Model: MET-C1b		Date: 27-Nov-14	No.: RD147125
Subject: Parts change information for BU3070 and Side tray		Prepared by: E.Hinata	
From: 1st Tech Service Sect., MFP/P Tech Service Dept.			
Classification:	☐ Troubleshooting ☐ Mechanical ☐ Paper path ☐ Product Safety	☒ Part information ☐ Electrical ☐ Transmit/receive ☐ Other ()	☐ Action required ☐ Service manual revision ☐ Retrofit information ☐ Tier 2

BU3070 Bridge Unit

Side Tray Type M3

Bushings added:

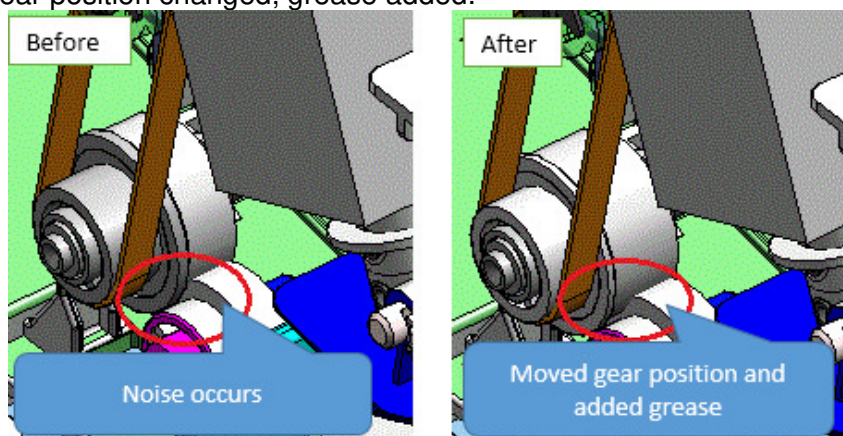
- 1) Bushings were added to the driven roller.
 - 2) The position of the gear was changed and grease was added.
 - 3) Some parts were deleted from service parts (but still included in assemblies).
- See tables below.**

Reason: To minimize noise that may occur when the gear contacts the roller.

IMPORTANT: Due to the above changes, make sure to replace the cover, side guide plate, and roller shaft **together as a set**.

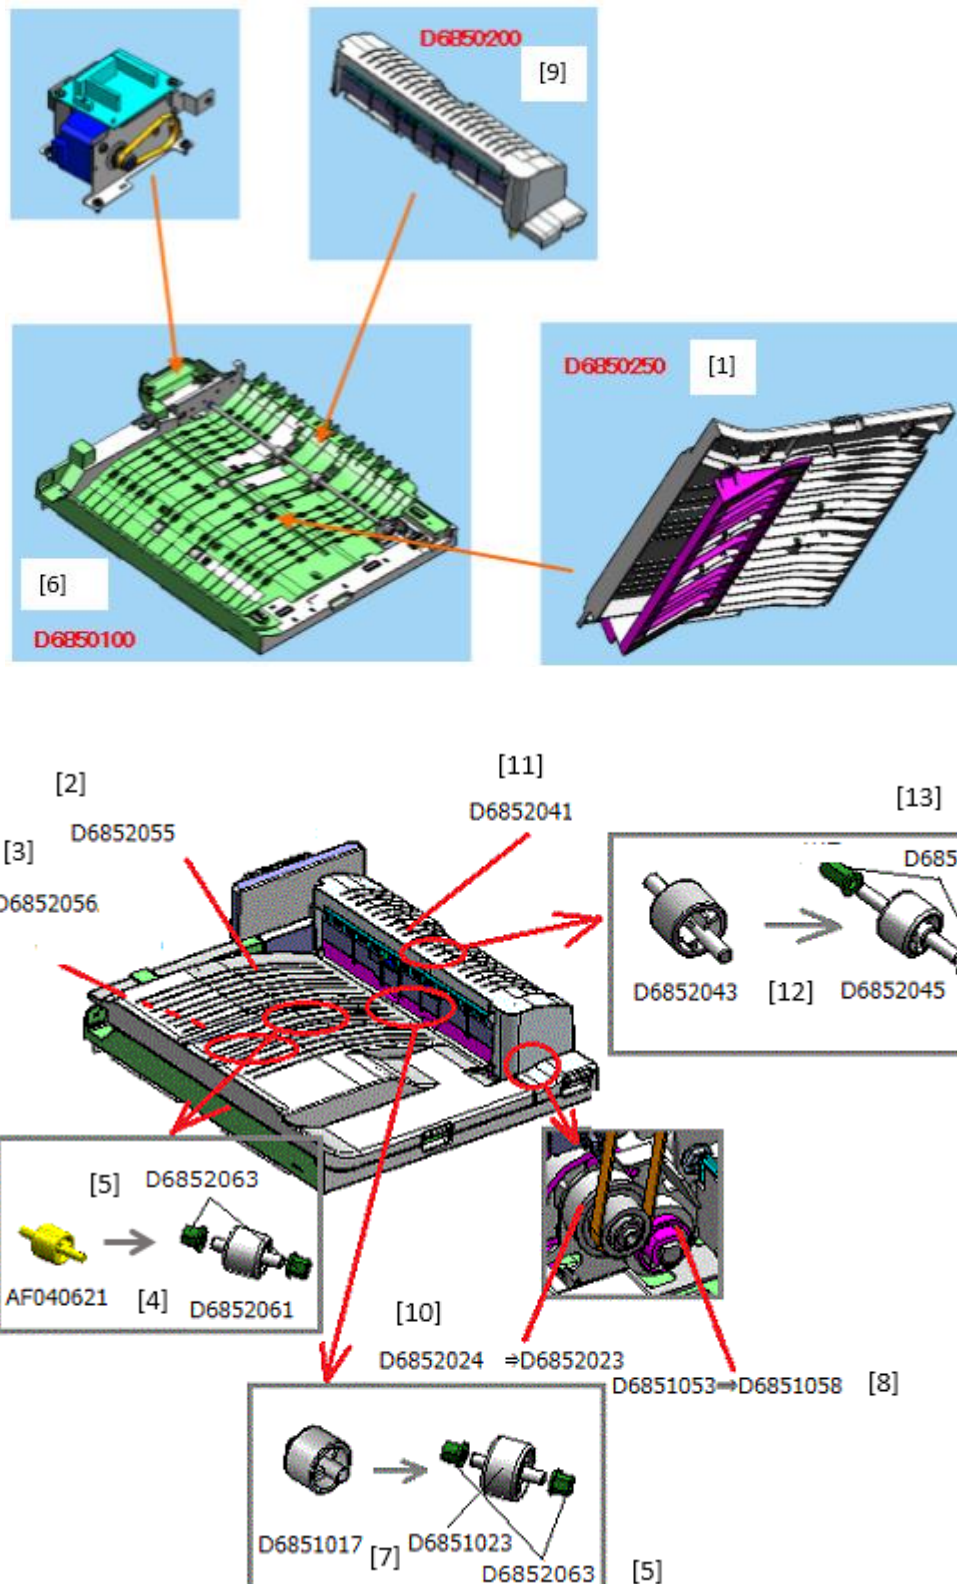
Gear position changed, grease added:

Important: Install parts #4 (D6852061) and #5 **together as a set**.

Note: Parts #2 and #3 were deleted from service parts. Part #1 is the assembly which contains these two parts.

Important: Install parts #7 (D6851023) and #5 **together as a set**.

Important: Install parts #12 (D6852045) and #13 **together as a set**.

Note: Part #11 was deleted from service parts. Part #9 is the assembly which contains this part.

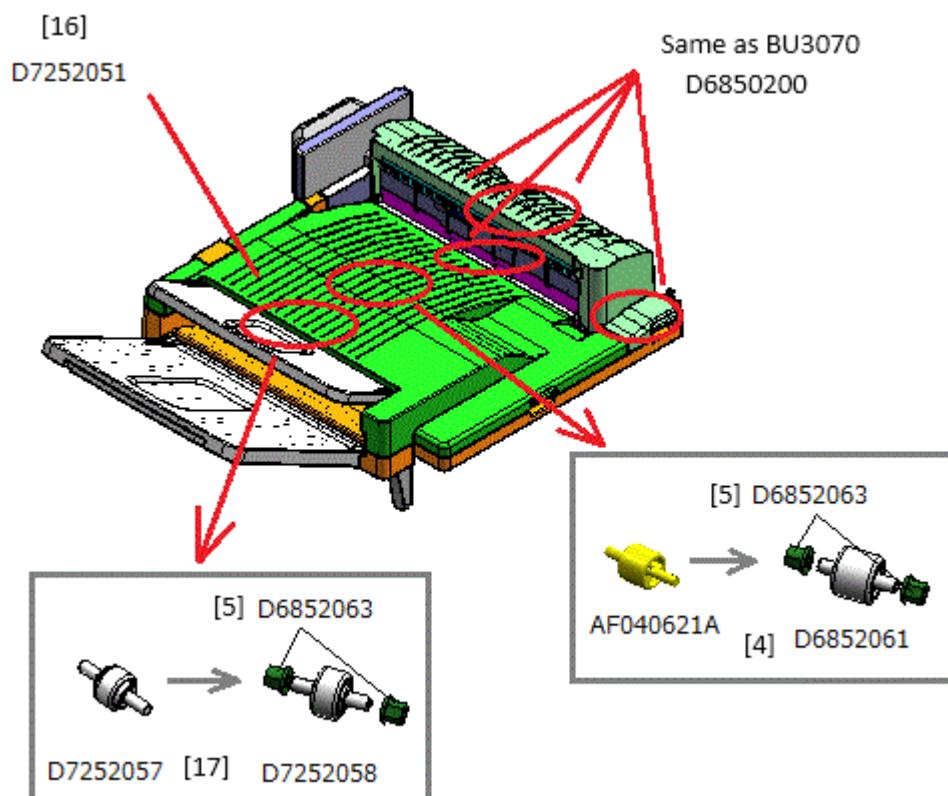
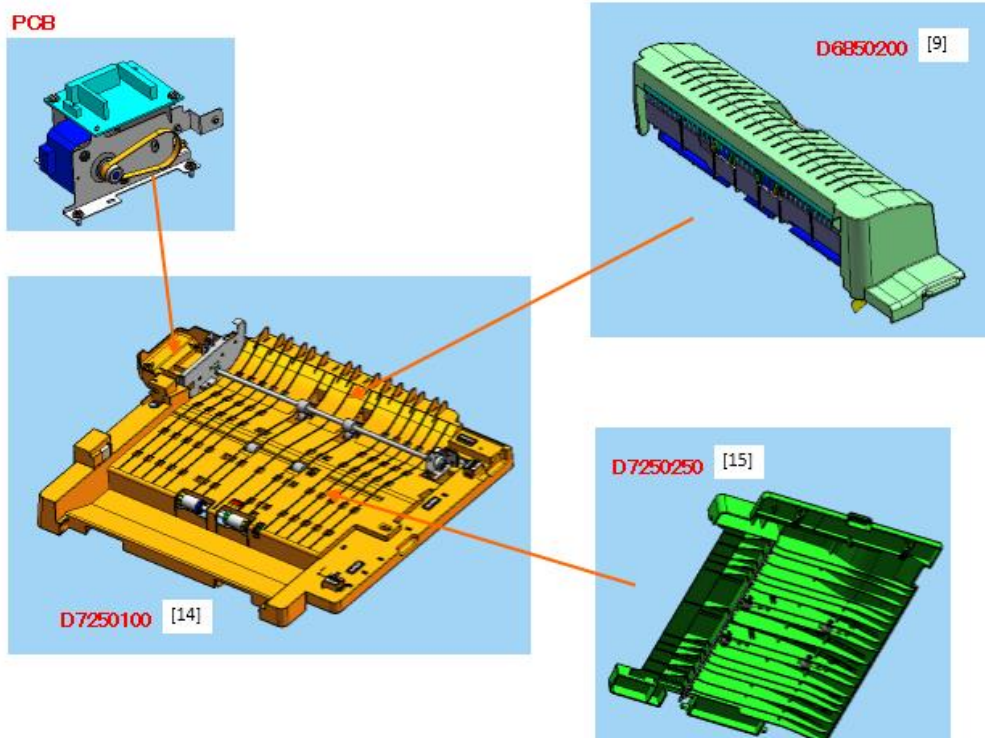
Important: Install parts #7 (D6851023) and #5 **together as a set**.

Important: Install parts #4 (D6852061) and #5, #5 and #17 (D7252058) **together as a set**.

Note: Part #16 was deleted from service parts. Part #15 is the assembly which contains this part.

Important: Install parts #12 (D6852045) and #13 **together as a set**.

Note: Part #11 was deleted from service parts. Part #9 is the assembly which contains this part
